VALUE ENGINEERING STUDY

Project # APD00-0056-02(029) PI No. 122900-

**SR 515/US 76 from CS 2898/Young Harris St
to CR 153/Timberline Dr
Union/Towns County, Georgia**

13 August 2015

PROPOSED CHANGE SKETCH/DETAIL

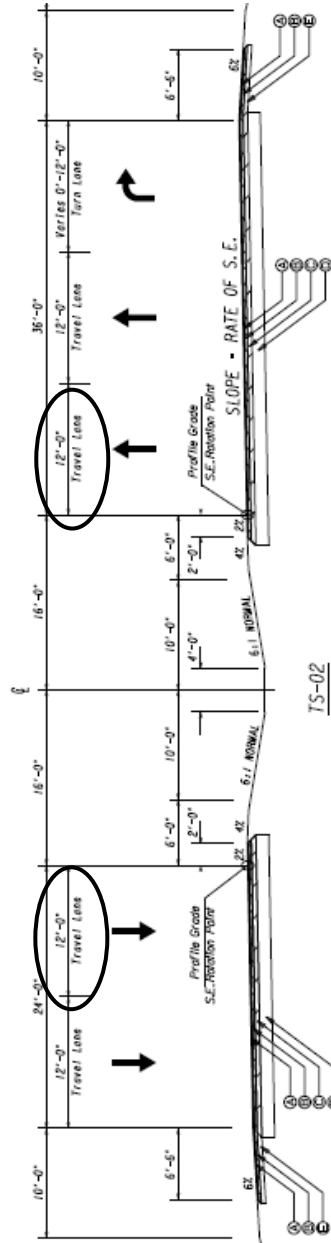
PROPOSAL DESCRIPTION: FOR NEW PAVEMENT SECTIONS ON 4-LANE
 DIVIDED SEGMENTS, USE 11' INSIDE LANE WIDTHS
 IN LIEU OF 12'

ORIGINAL DESIGN: In the current design, all lane widths on new pavement sections are shown as having 12' widths.

PROPOSED CHANGE: It is proposed to construct the inside lanes on the 4-lane divided sections of roadway with an 11' width in lieu of 12'. The 4-lane divided section of the project extends from Sta 116+00 to 420+38.

JUSTIFICATION: With a full-depth 2' wide inside shoulder and with most trucks traveling in the right lane, an 11' wide inside lane should be sufficient. The data from the AASHTO Highway Safety Manual indicates that the Crash Modification Factor is virtually the same for 11' and 12' lane widths on divided roadway segments (see chart on the Sketch sheet within this proposal). This change will provide an acceptable design for divided roadways while also providing a construction cost savings to the project.

Proposed Change: Revise 12'0" inside lanes to 11'0" max.

Current Median Design

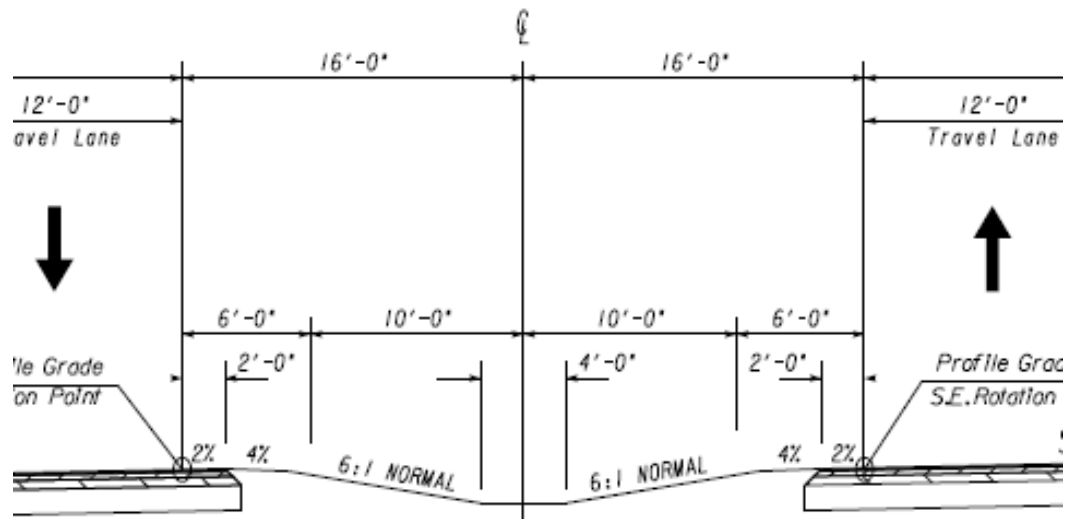
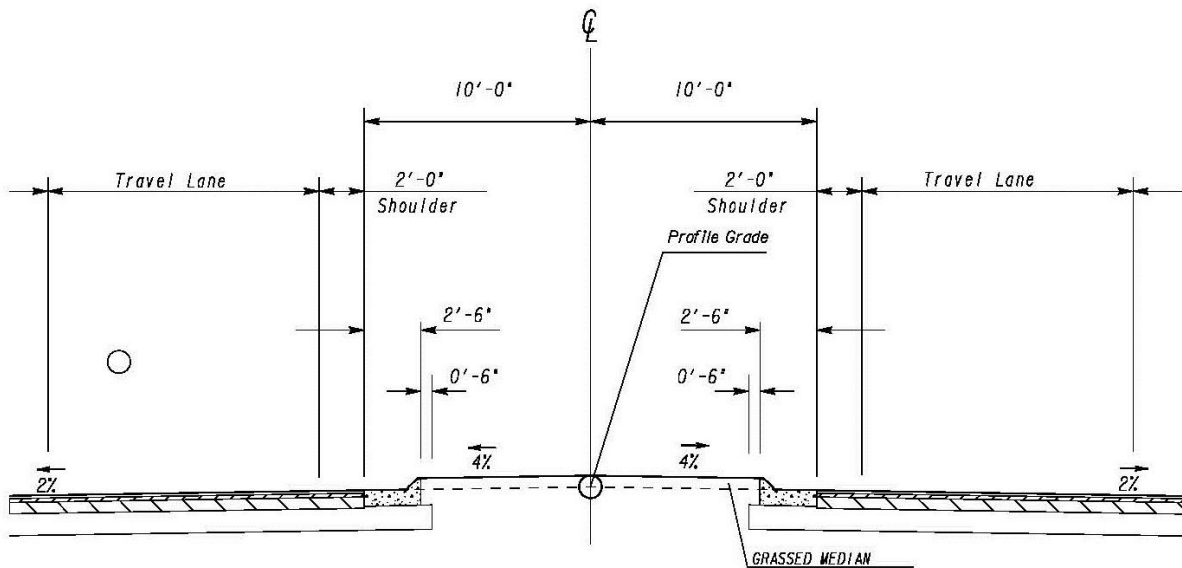
PROPOSAL DESCRIPTION: CHANGE THE MEDIAN FROM A 32' DEPRESSED GRASSED TO A GDOT STANDARD 24' RAISED GRASSED MEDIAN FOR THE 4-LANE DIVIDED SECTION.

ORIGINAL DESIGN: In the current design, the 4-lane divided section from Sta. 116+00 to Sta. 426+00 has a 32' depressed grassed median.

PROPOSED CHANGE: It is proposed to use a standard GDOT 24' raised grassed median for the 4-lane divided section from Sta. 116+00 to Sta. 426+00.

JUSTIFICATION: The 24' raised grassed median is allowed in accordance with GDOT Design Policy Manual Table 6.6 for a 4-lane 55 mph rural Arterial Roadway. This greatly reduces the project footprint, reduces disturbances and impacts to property owners.

PROPOSED CHANGE SKETCH/DETAIL

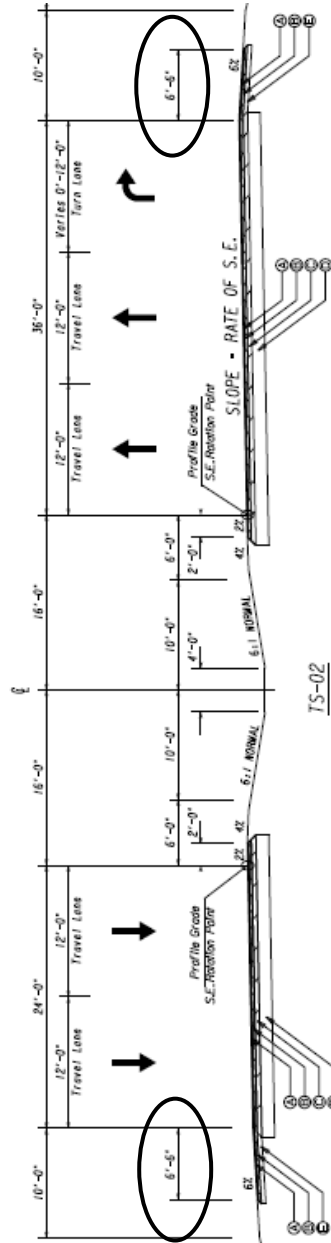
PROPOSAL DESCRIPTION: REDUCE WIDTH OF OUTSIDE PAVED SHOULDER
 FROM 6.5' TO 4'

ORIGINAL DESIGN: In the current design, the paved portion of the outside shoulder is 6.5'.

PROPOSED CHANGE: It is proposed to reduce the paved width of the outside shoulder from 6.5' to 4'.

JUSTIFICATION: This project is on a local bike route. The AASHTO Policy Manual for Geometric Design of Highways and Streets, Section 7.2.3, allows a 4' paved width for shoulders where bicycles are to be accommodated. Thus, this proposed change meets AASHTO standards while providing a cost savings to the project.

Proposed Change: Revise 6'6" outside shoulder to 4'0" max.

R-9.0 Current Design
Page 3 of 5

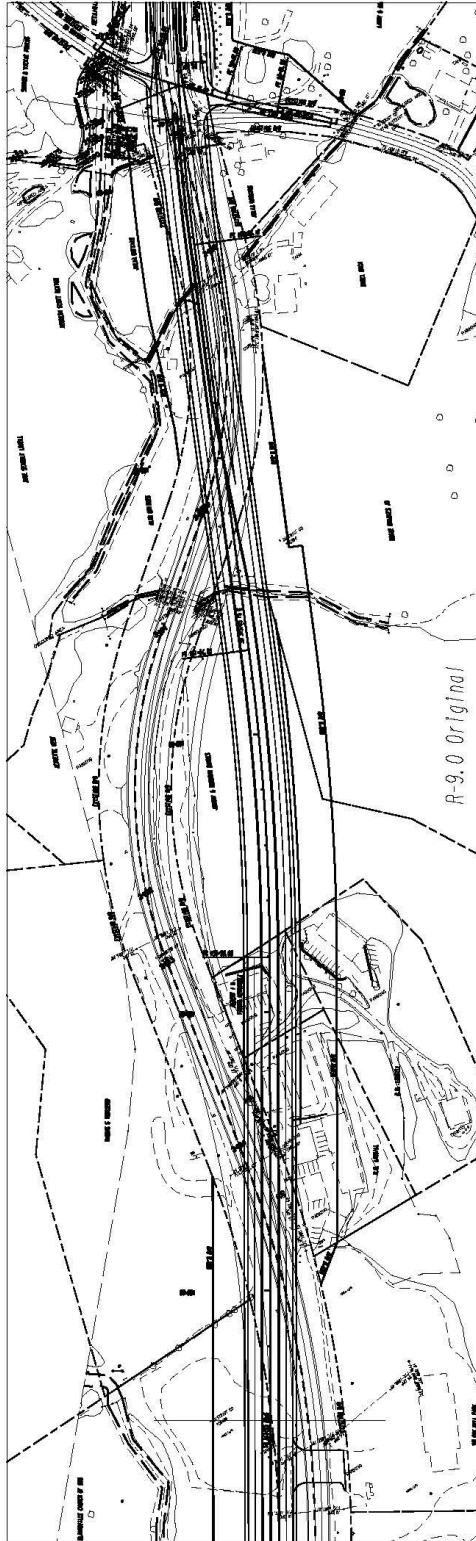
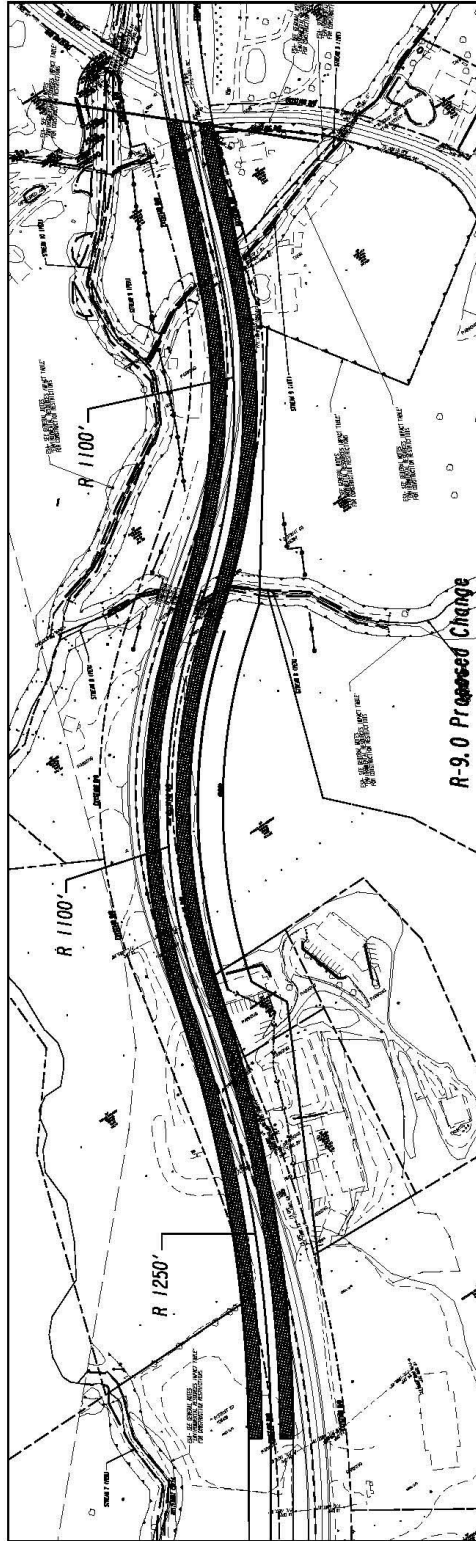
PROPOSAL DESCRIPTION: FROM STA 130+00 TO STA 170+00 SHIFT HORIZONTAL ALIGNMENT CLOSER TO EXISTING ROADWAY TO REDUCE RETAINING WALLS AND MINIMIZE PROPERTY IMPACTS.

ORIGINAL DESIGN: From Sta 130+00 to Sta 170+00, the current design significantly shifts the proposed alignment away from the existing roadway. The shift results in large cut sections and tall walls.

PROPOSED CHANGE: It is proposed to shift the alignment to better align the proposed roadway with the existing roadway. The proposed alignment includes curves with radii of 1100' and 1250', which are adequate for the 55 mph speed. Proposed alignment shift will reduce wall height and excavation costs. Additionally, the proposed change will reduce property impacts and the costs associated with right of way acquisition and relocation.

JUSTIFICATION: The current design includes a significant realignment of the roadway and results in large cut sections and large retaining walls. Adjusting the alignment closer to the existing roadway, with curves that are adequate for the corridor speed, provides a significant cost savings and reduces property impacts, earthwork and retaining walls.
